Seattle Design Commission

APPROVED MINUTES OF THE MEETING 6 January 2005

Projects Reviewed

Phase I Site Development - Schematic Design

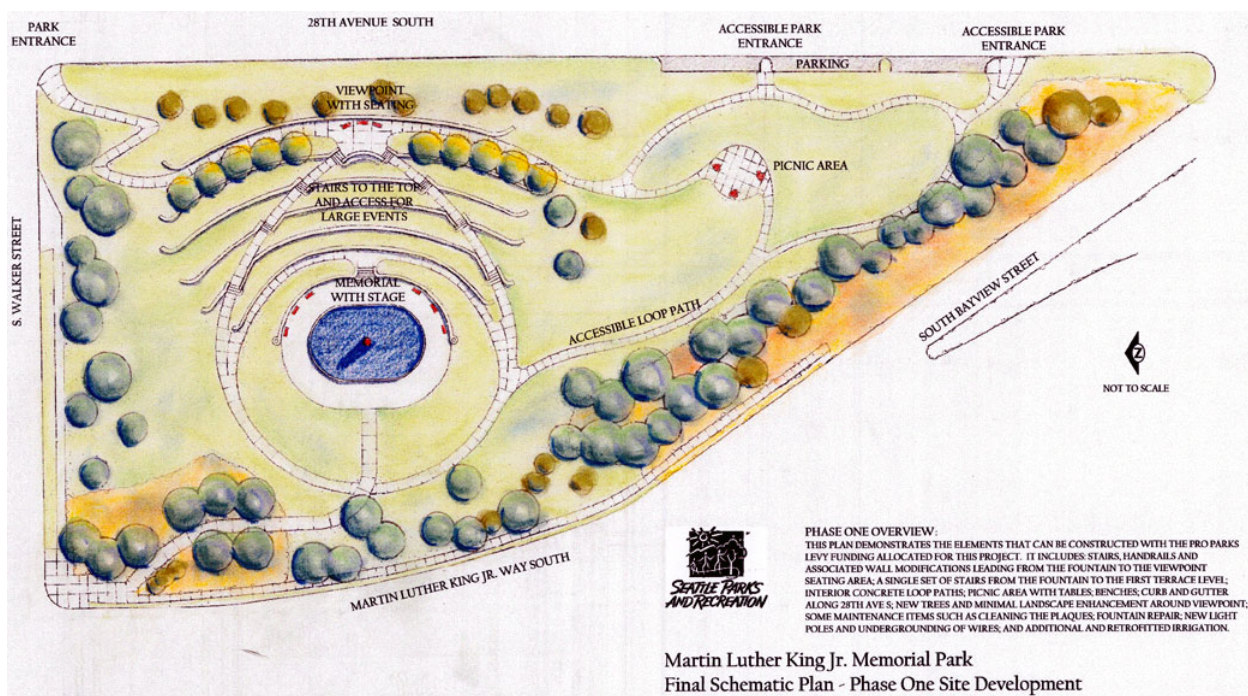
- Asks proponents how they believe the existing park has been successful and unsuccessful at meeting the park's mission.
- Proponents stated that the fountain is successful because it provides a focal point, creates energy and tributes the life of MLK, Jr. They stated that the amphitheater is unsuccessful because it is difficult to access, if not inaccessible, and thus, deters people from using this area of the park.
- Questions keeping the sculpture and fountain as focal point; feels that it interrupts the function of the amphitheater.
- Asks for clarification in regards to Master Plan and Phase I Plan and what \$475,000 budget will accomplish. Questions if proposed changes are feasible given their existing budget.
 - The \$475,000 will cover Phase I costs, funding is not yet available for entire Master Plan.
- Asks if fountain and sculpture can be moved.

- Suggests changing fountain to stage space by either moving fountain or bridging over it.
- Expresses concern about holding on to an unsuccessful element and trying to improve it, suggesting that it is not good in the long run.

- Suggests moving fountain at a later time when the budget allows it, and focusing on other efforts at this time.
- Suggests installing a temporary stage on top of fountain that can allow amphitheater function.

- Expresses concern with using expensive materials, specifically granite, due to budget constraints.
- Cautions screening MLK, Jr. sculpture too much with plantings; restricting necessary visibility.

- Reminds proponents not to install plantings in areas that will be changed in later phases.
- Encourages installing planting plan proposed in master plan during Phase I, even if pathways can not be installed at that time, the trees will create structure and visual corridor.

- Suggests that parking on the east side of the park be moved closer to the overlook to increase accessibility to the memorial.
- Proponents replied that they made a conscious effort to remove parking from the memorial experience, so provided nine parallel parking spaces on the south east end of the street.

- Encourages parking along the full length of the street; does not believe that it will interfere with experience due to the existing grade change and suggests that parallel parked cars will help provide a buffer from street traffic.

- **appreciates how proponents made the most of the good qualities of the park; the overlook, the stairs and the picnic area.**
- **generally questions the location of the fountain and the sculpture; that perhaps they are not located in the right place, and they interfere with the function of the amphitheater as an event space.**

- **suggests the use of plantings to better define the amphitheater space but also maintain visual access into the park.**
- **suggests that Phase I include improving visual access into the park, especially in its northwest corner, encouraging that the regrade and planting proposed for the northwest entrance be included in the Phase I plan.**

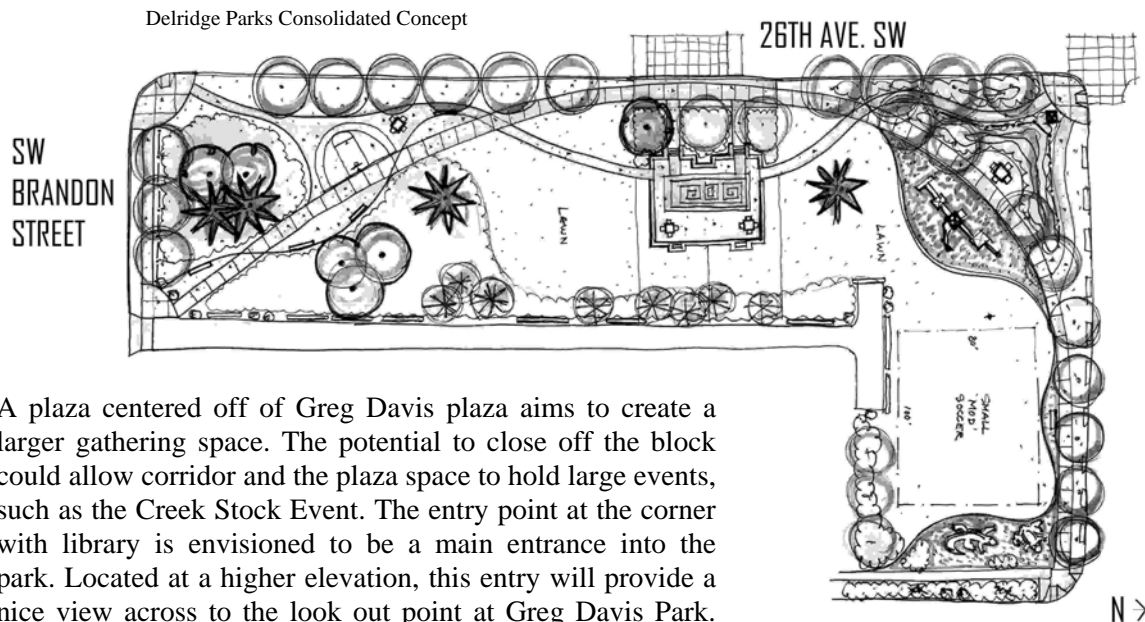
- Suggests that there is no cohesive whole of the design; that it instead looks like isolated elements strung along.
- Suggests that the proponents' attempt to incorporate all of the disparate elements expressed during the community meetings weakens the design overall.

- Recommends that the proponents develop a cohesive, clear design.
- Suggests that proponents need to strengthen the connection to Greg Davis Park.
- Suggests changing parking from the p-patch to 25th/26th street, if possible.

- Suggests that spaces seem discontinuous and perhaps the arc concept could be a series of spaces rather than the sidewalk that connects them.
- Believes that the P – Patch creates a blockage in its current location. Recognizes that community wants P – Patch to remain in its current location but encourages proponents to be an advocate for the greater space.

- Argues that the arc looks good in plan but that no one will walk it as proposed; the arc might be a good armature to organize the program but needs to be enforced.

- **encourages the proponents to not feel too fixed in the layout presented at this time.**
- **appreciates the community's comments that bring to our attention how the design would be improved by incorporating some reflection of the local cultural diversity and the creation of an artistic vision for the park, regardless to whether or not it is funded.**

- **encourages the proponents to review the program elements added to the site in response to community interest and suggests that they be further integrated into a clearer design that responds to all three sites and the surrounding neighborhood.**

Off Leash Area – schematic design and cross sections 3 and 4

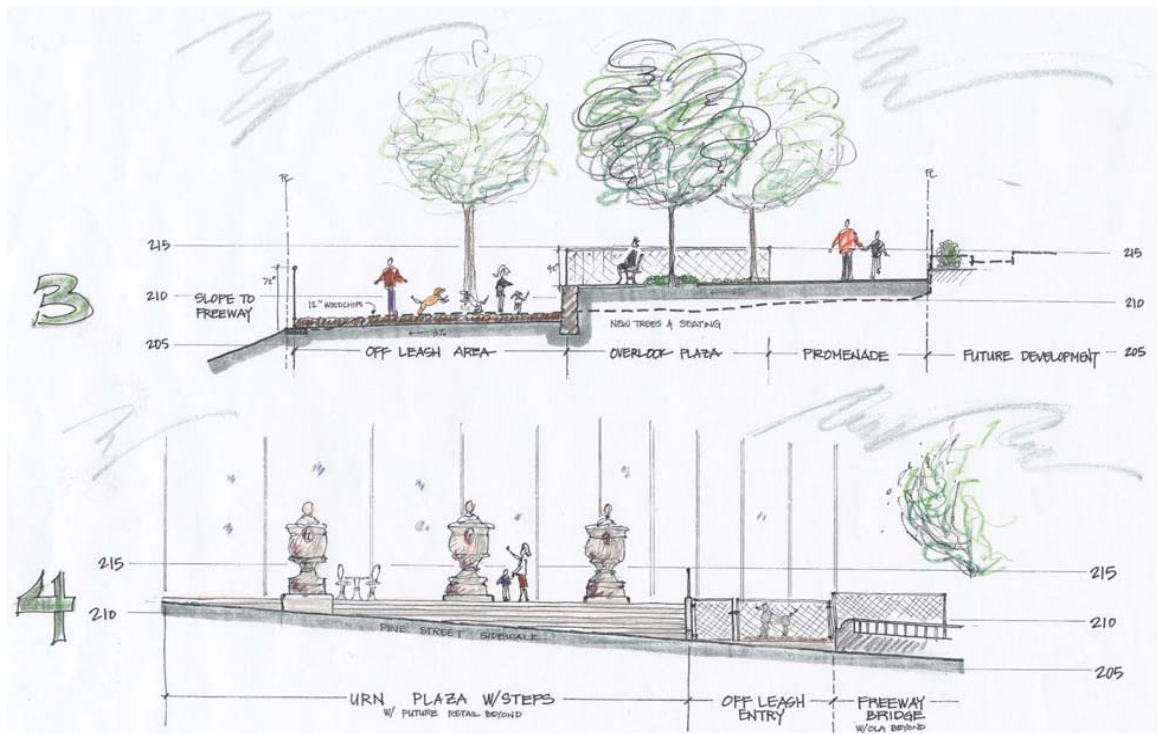
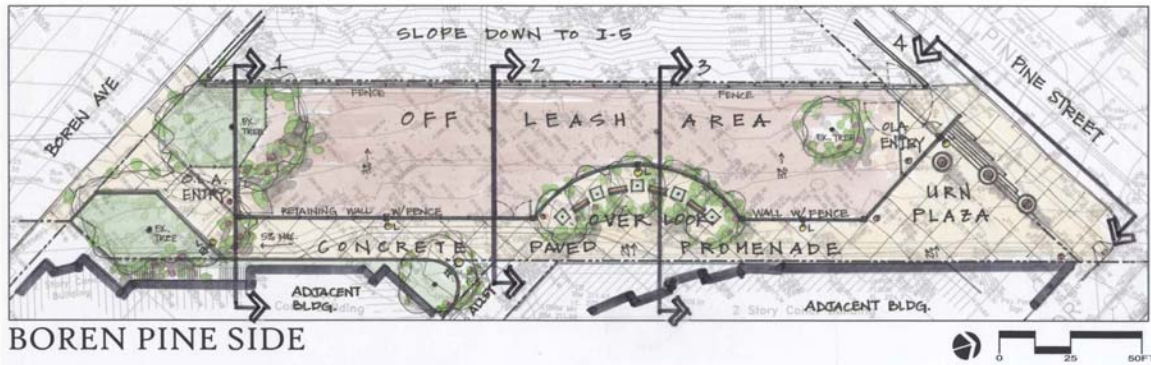
- Asks the width of the promenade and the off leash area
 - The promenade is 14' wide. The off leash area is 30' wide.
- Asks how one enters the off leash area

- Yes, there will be a fence above the vertical retaining wall.
- Asks if it will be a chain link fence
 - Yes, but black, small and discreet
- Suggests the use of a nice fence since it is one of the only design elements of the park.

- Funding restraints may restrict us from using a nicer material.
- Encourages pushing an urban “feel” to the park.
- Suggests moving the fence line to align with the column park side making the two areas feel like one park

- Suggests the use of a more substantial urban guard rail rather than a chain link fence between the promenade and the off leash area.
- Suggests making a stronger urban gesture to better match the urban environment off of Boren Street.

- Suggests using a nicer material for the fence at least in the overlook area if it is unaffordable to use for the entire fence length.
- Asks if entrance could be located off of plaza rather than Pine St. to allow more breathing space

- **endorses the urban off leash area.**
- **suggests pushing the urban feel of the park and creating an interesting entrance.**
- **suggests using fence material other than chain link fencing unless it is used creatively. recommends that the planters be removed from the column staircase to promote a simpler space.**

- **suggests that Pine St. entry to the off-leash area be pulled off of the street, but recognize that there may be some grading issues in order to do so. In response to the notion of creating commercial activity in the park, the Commission agrees that the presence of tables and chairs in Urn Plaza will just provide this kind of space, and will encourage neighbors and passersby to use the space.**
